PLANNING COMMISSION STAFF REPORT

AGENDA ITEM: Century Ponds Proposed Development, 601 Century Avenue South

Public Works Plan Review

PLAN SET: Plans dated 7-22-2025

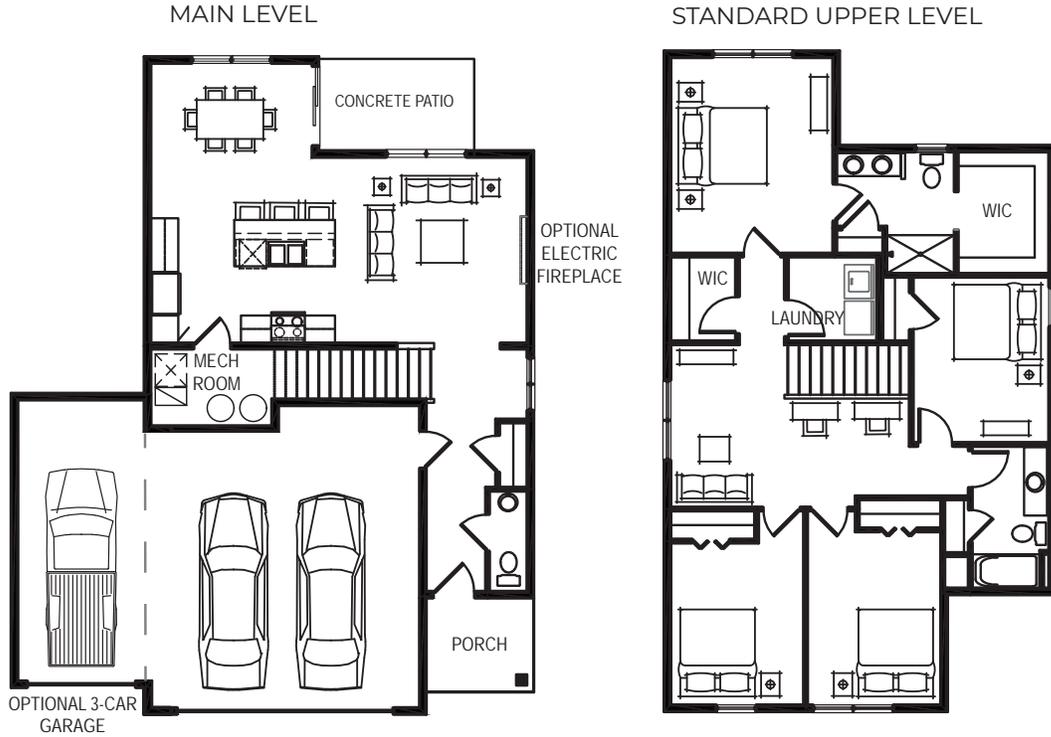
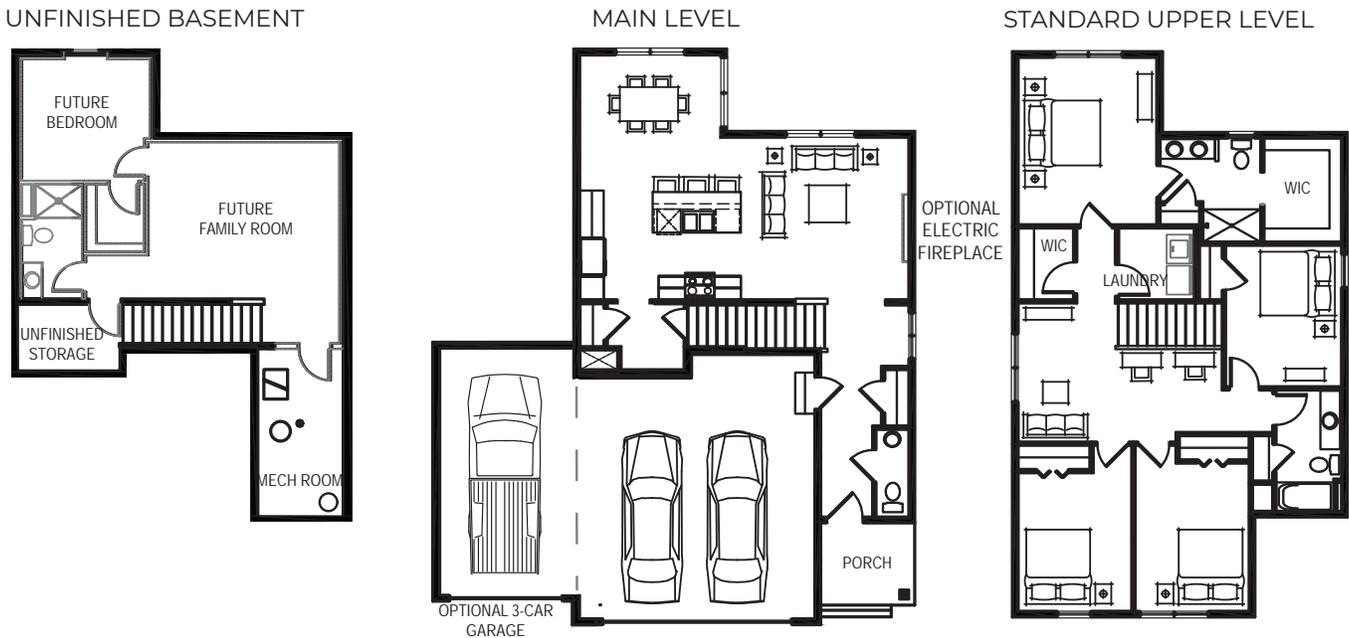
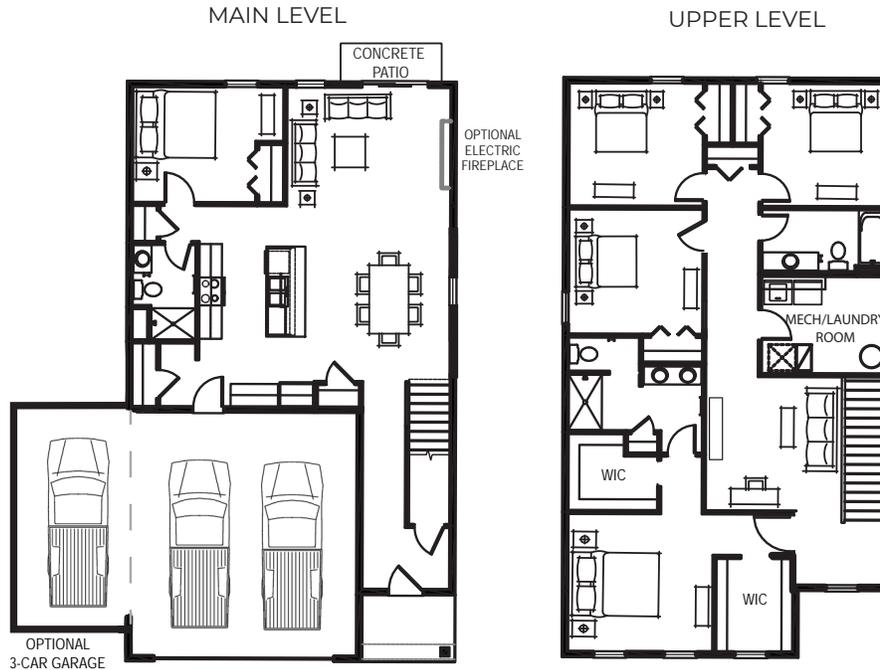
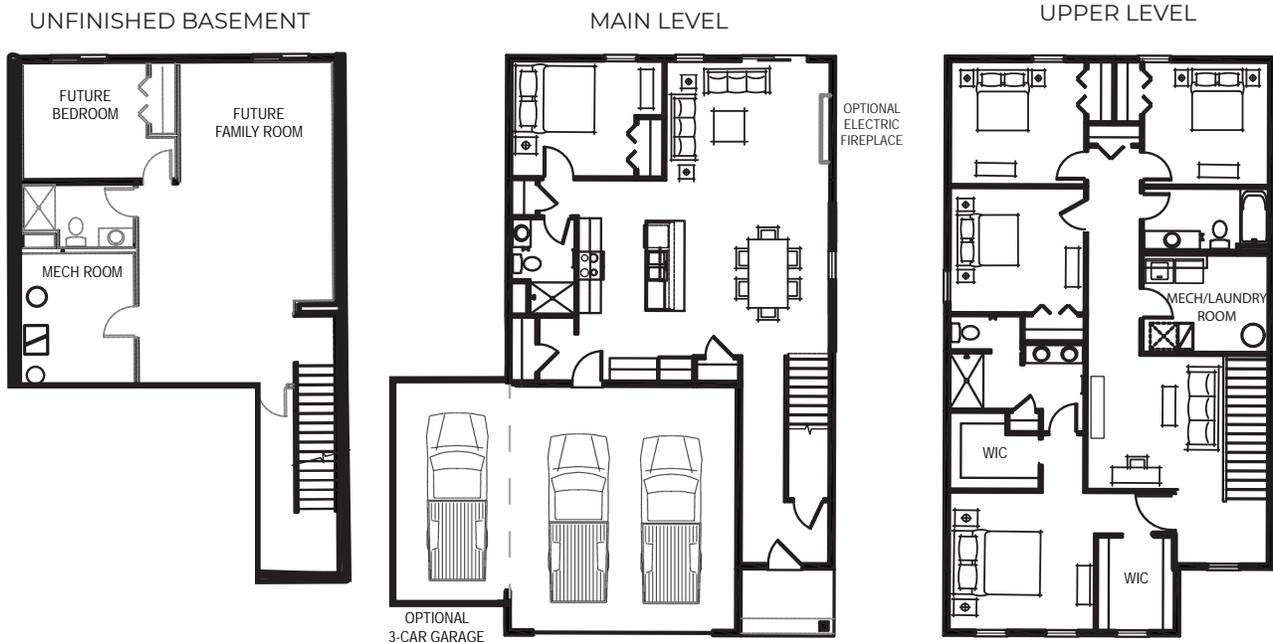
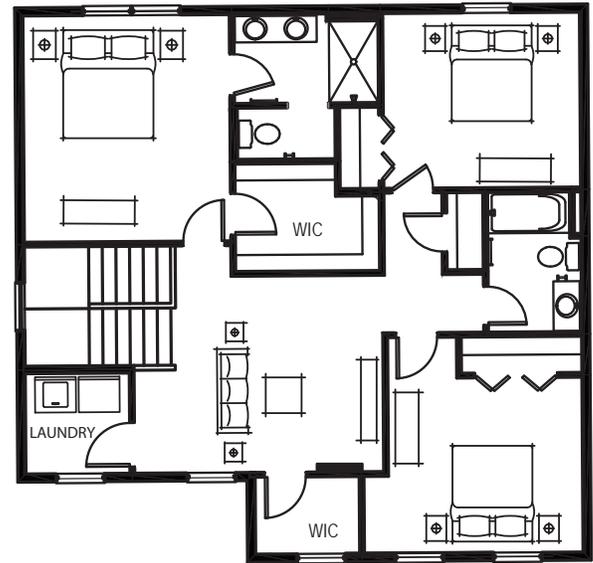
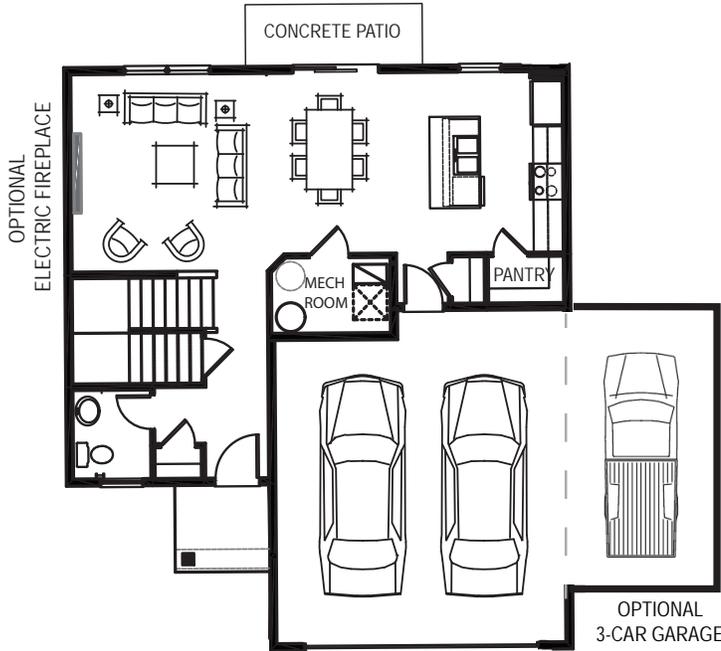
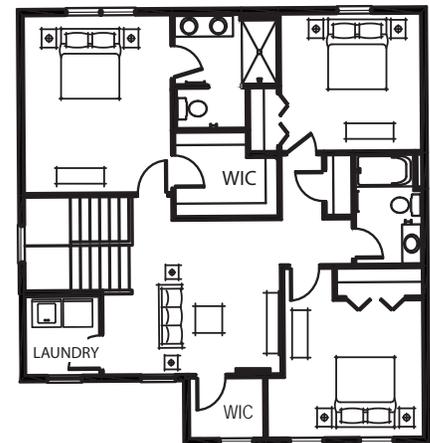
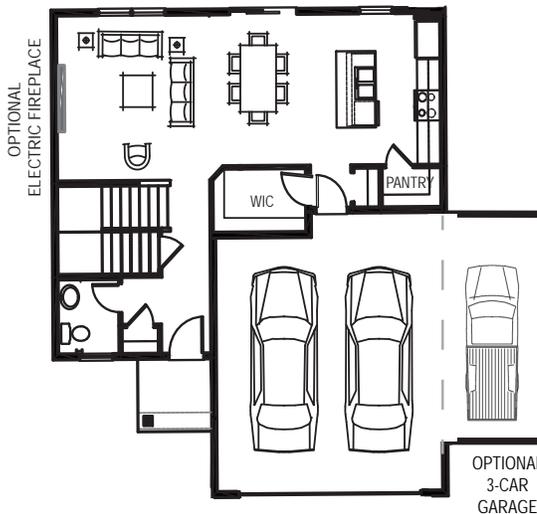
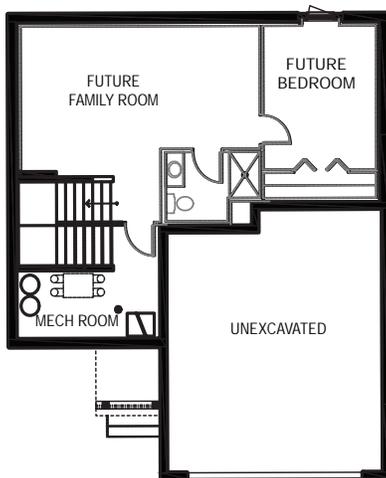
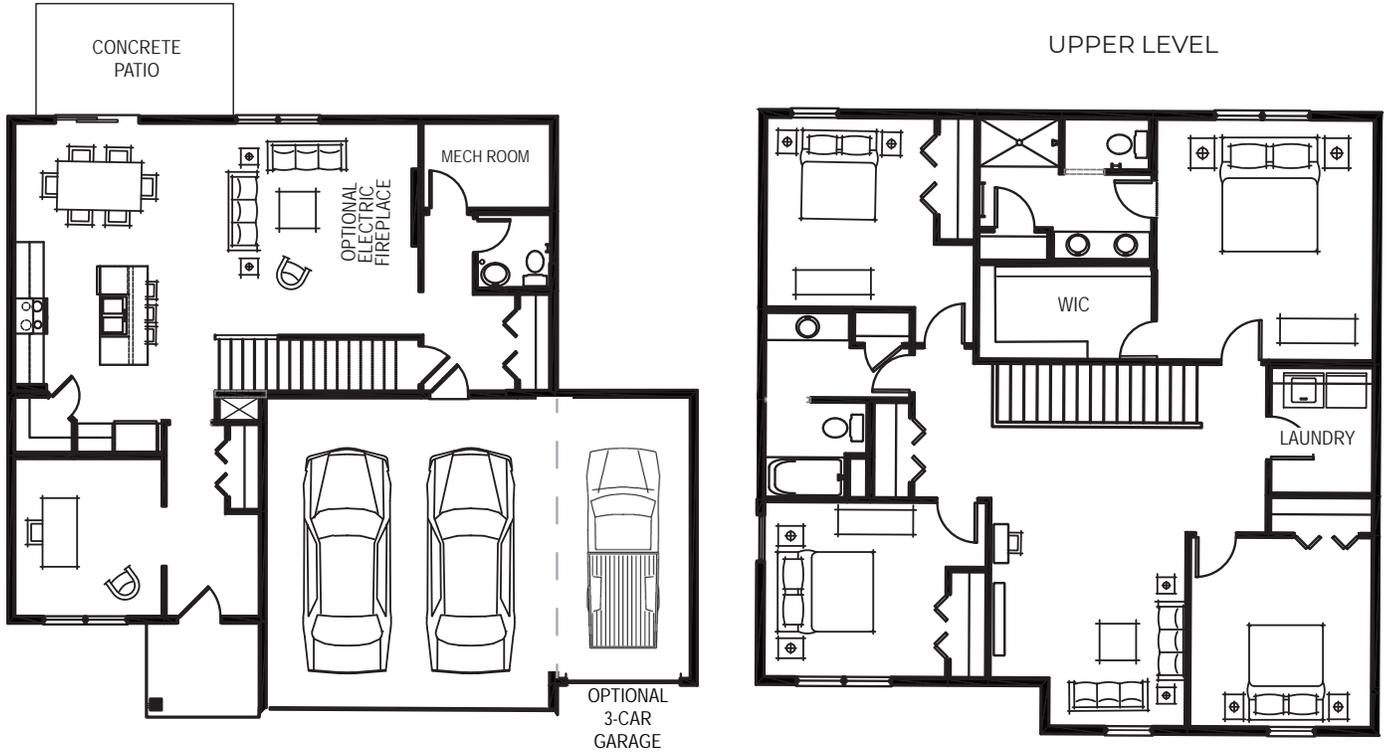
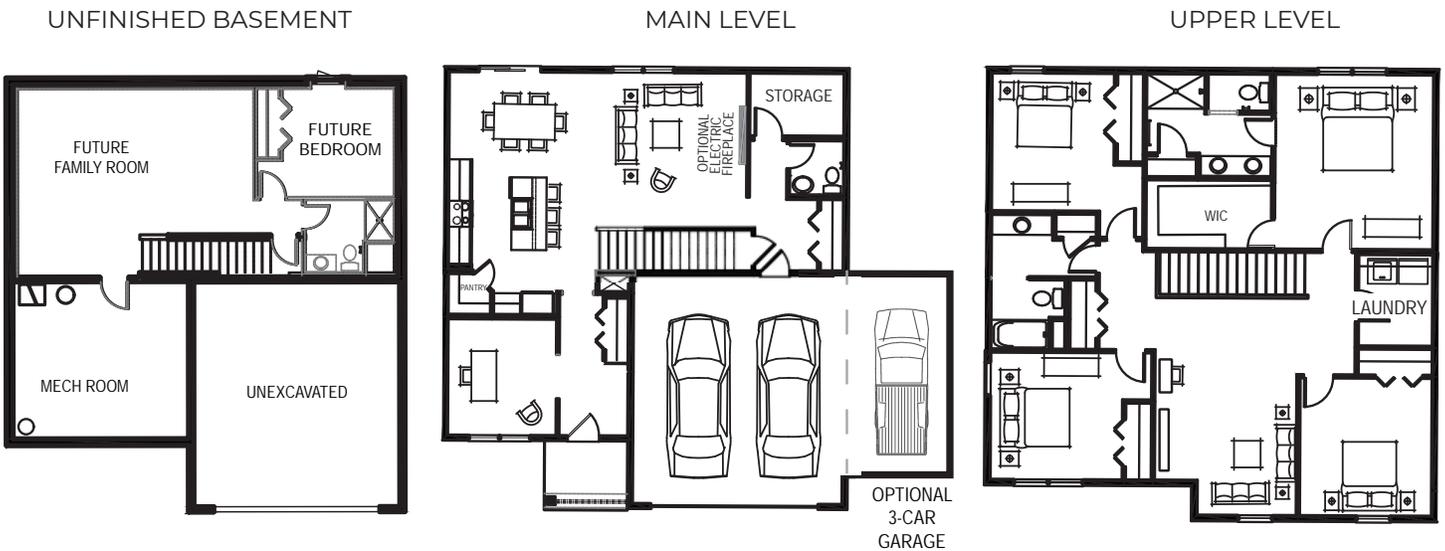
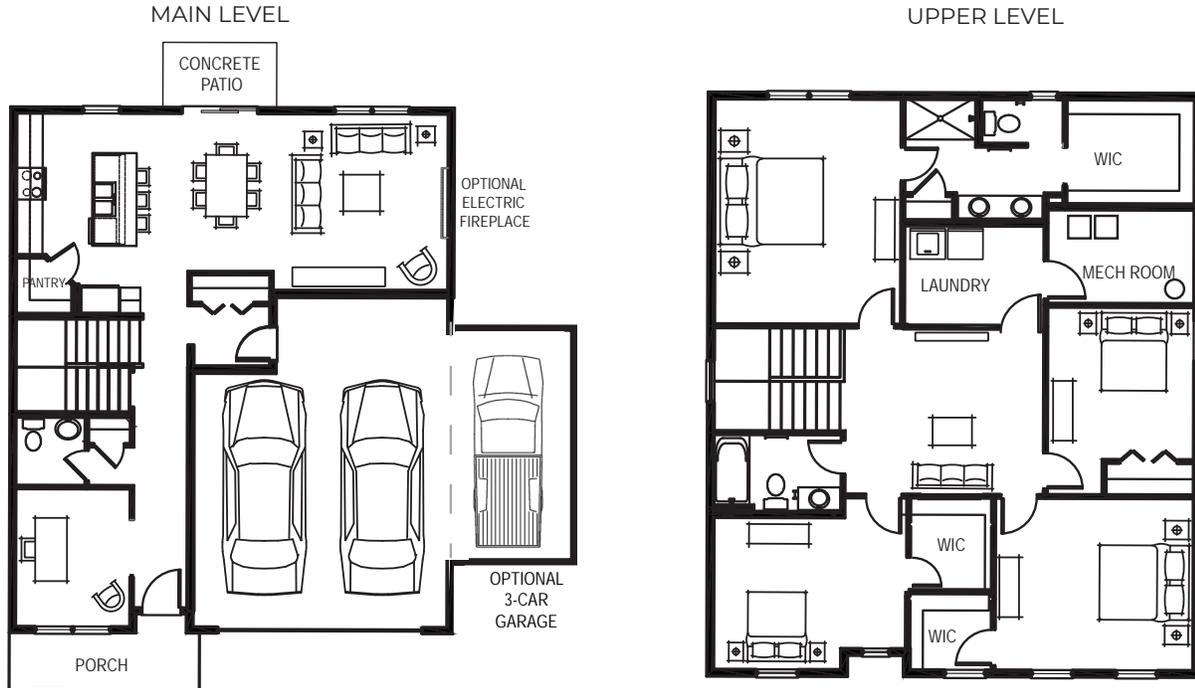
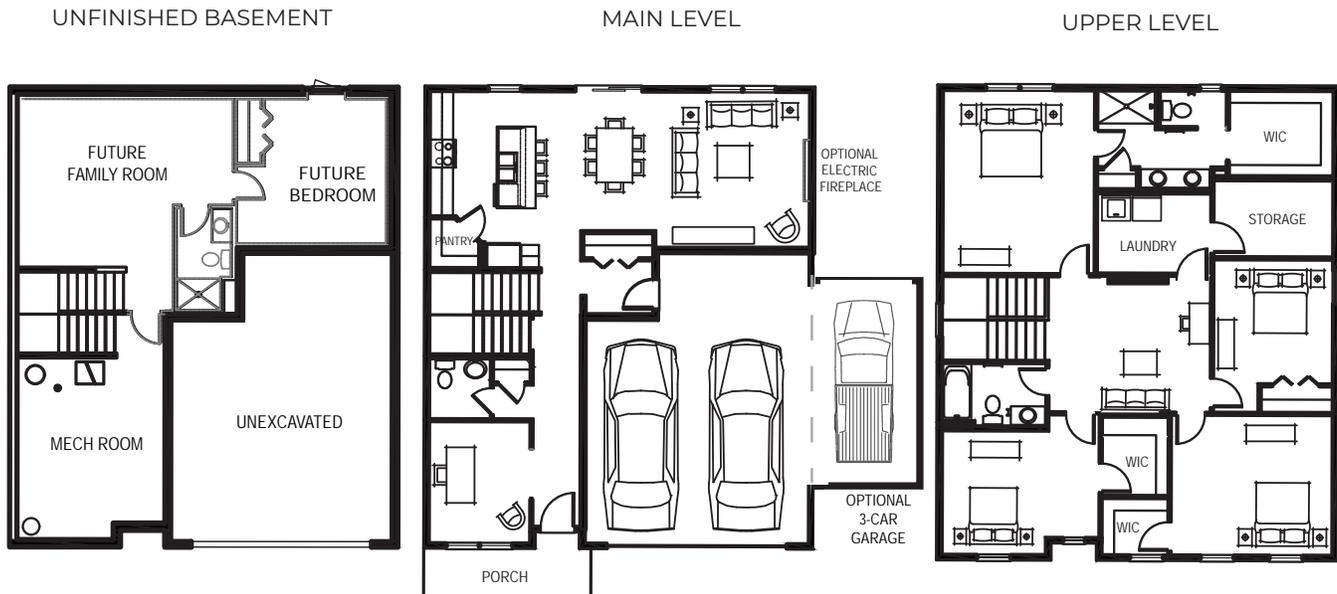
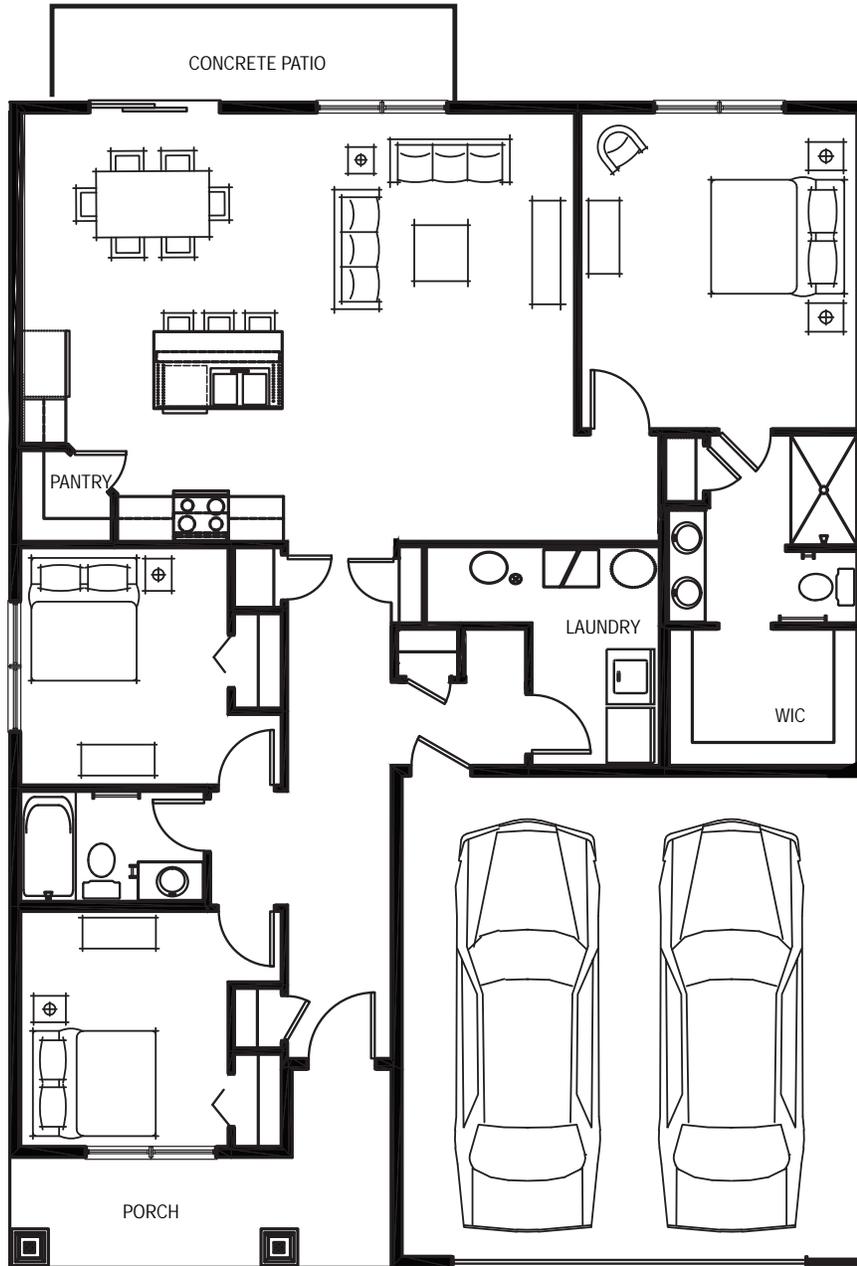
The exterior design and appearance of all single-family homes in this PUD must be approved by the director of community development. The review is required to ensure the exteriors of the homes are not similar in design. No single-unit home will be constructed with the same floor plan or exterior facade as a home immediately adjacent to it or across the street. In addition, all single-unit homes and townhomes shall be constructed of building materials that mitigate the noise from the adjacent shooting range.
